From:
To: [Committee of Adjustment \(SM\); Sean Harrigan; Debbie Chapman](#)
Subject: Committee of Adjustment Concerns - 96 Wood Street
Date: Tuesday, September 10, 2024 7:25:02 PM
Attachments: [96 Wood Street - Plan.pdf](#)

Re: A-2024-075 - 96 Wood Street

Requesting minor variances to permit a visibility obstruction (a fence) having a height of 1.83m within one side of the Driveway Visibility Triangle (DVT) rather than maximum permitted height of 0.9m within the DVT; a lot area of 393 sq.m. rather than the required 450 sq.m; a front yard setback of 3.8m rather than the required 4.5m; an exterior side yard setback abutting York Street of 2.5m rather than the required 4m; a building height of 12m rather than the maximum permitted 11m to facilitate the redevelopment of the property into an 8-unit multi-residential dwelling.

TREES AND LANDSCAPING

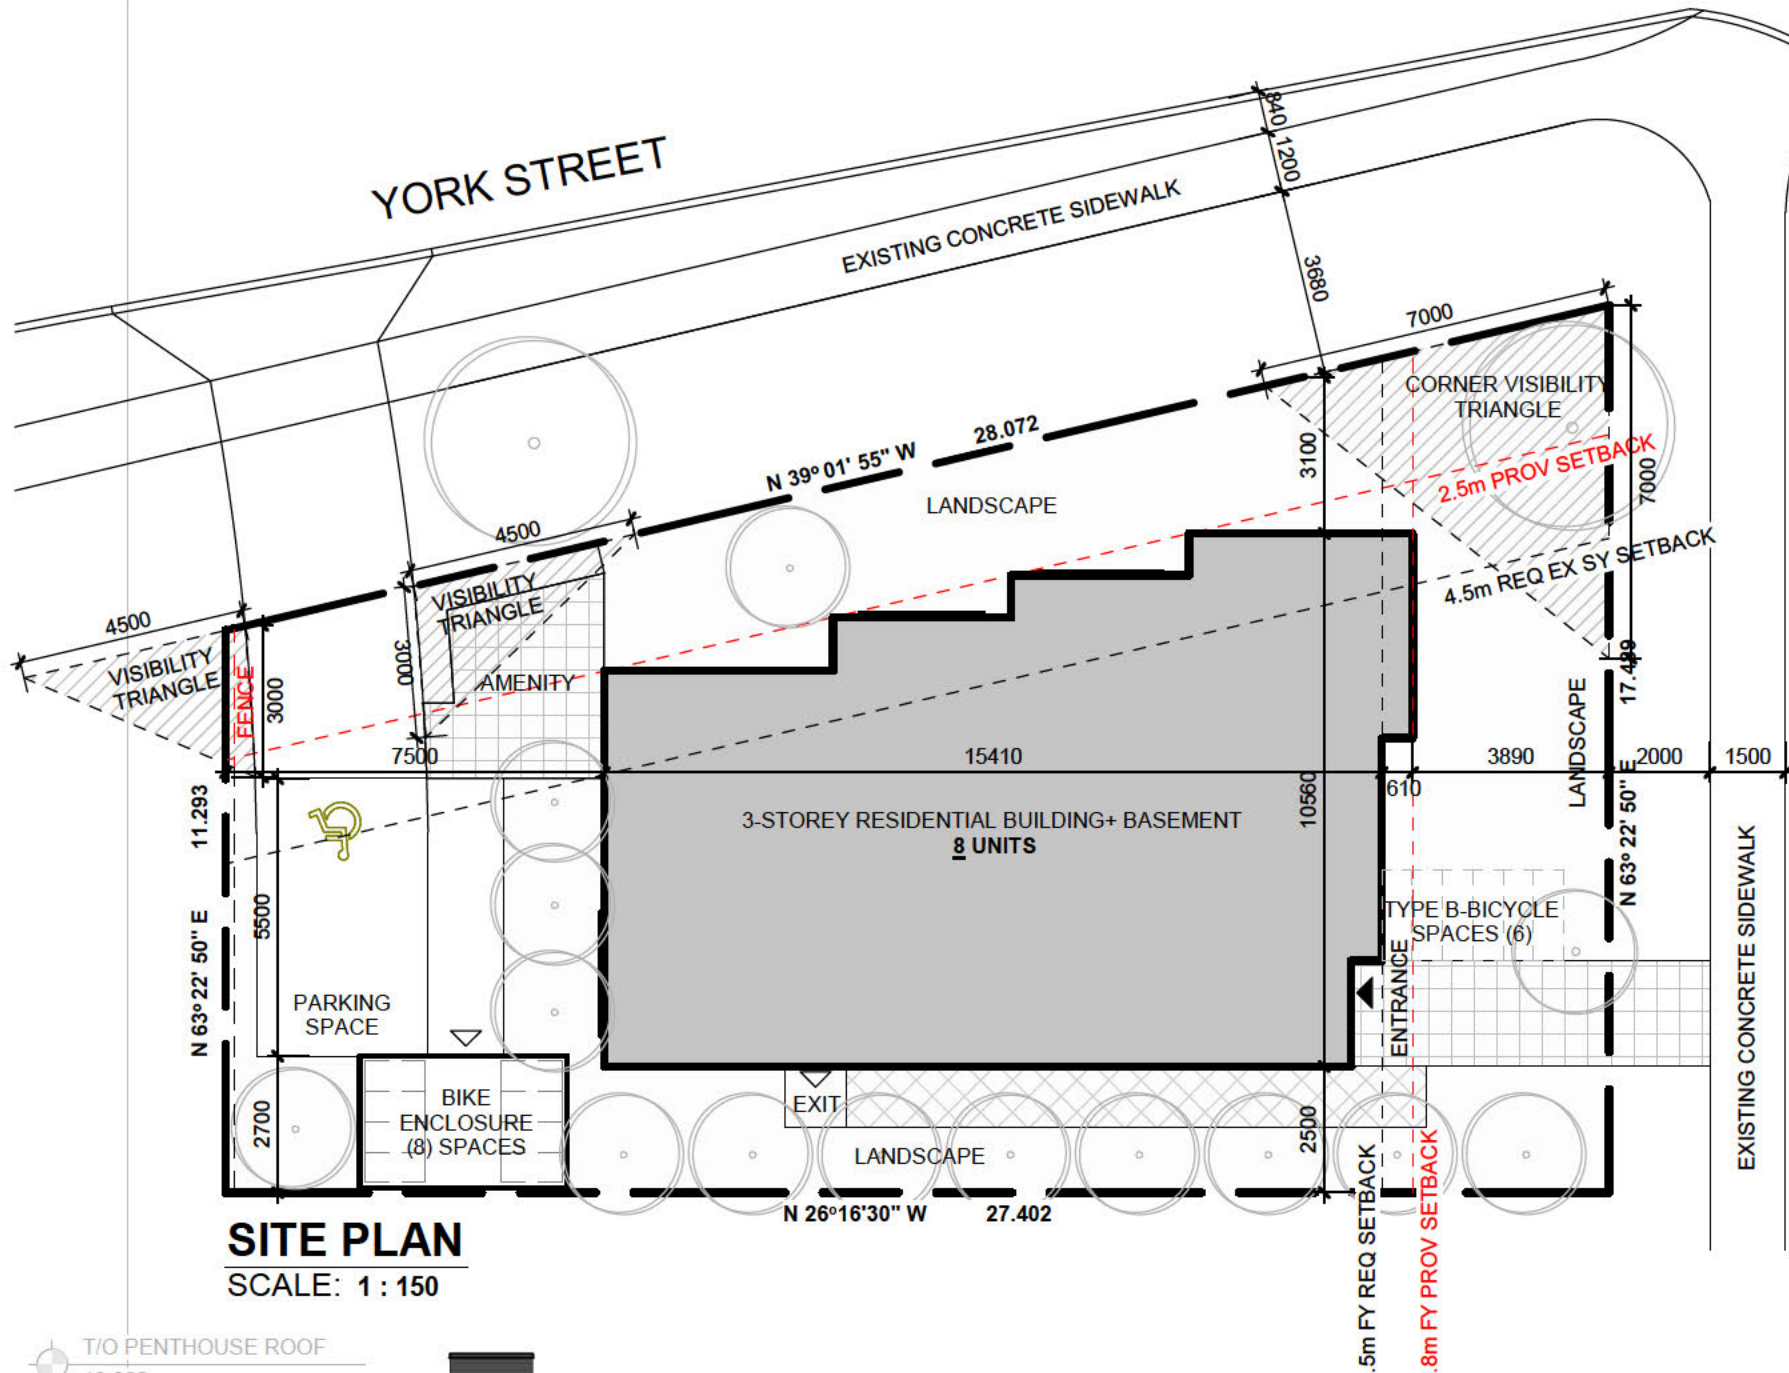
The applicant did not provide a tree preservation plan. Staff are still evaluating tree retention. Please be aware there is a growth tree situated on the new entrance path and another old growth tree to the right of the driveway.

SITE PLAN
SCALE: 1 : 150

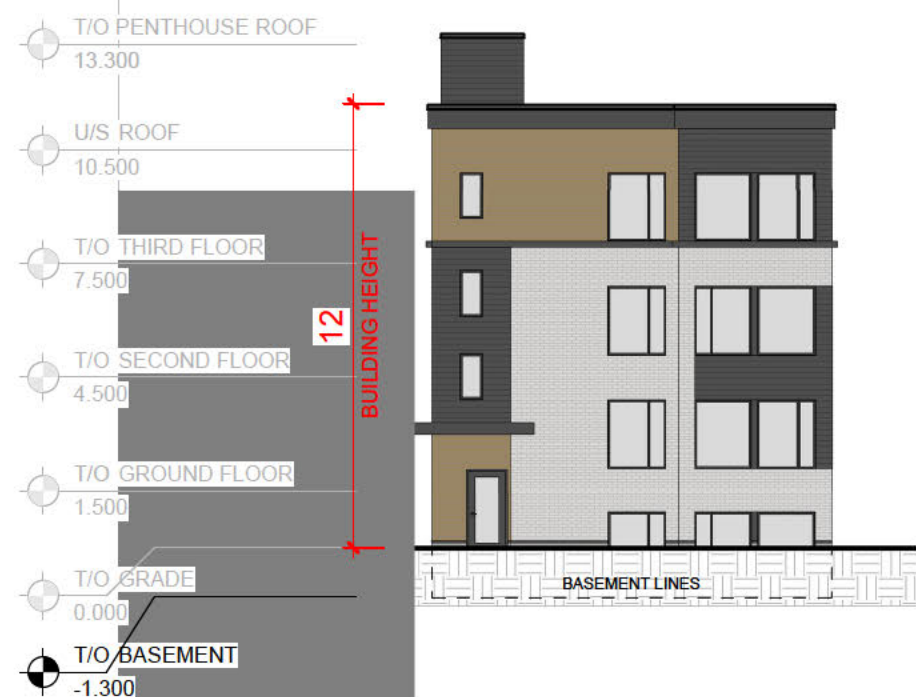
The applicant has not outlined the mass waste enclosure for the 8-unit plan. While this detail is not an application requirement, it's disrespectful not to proactively include this information for adjacent homeowners. Furthermore, there doesn't appear to be remaining outdoor space in the plan for a mass waste enclosure.
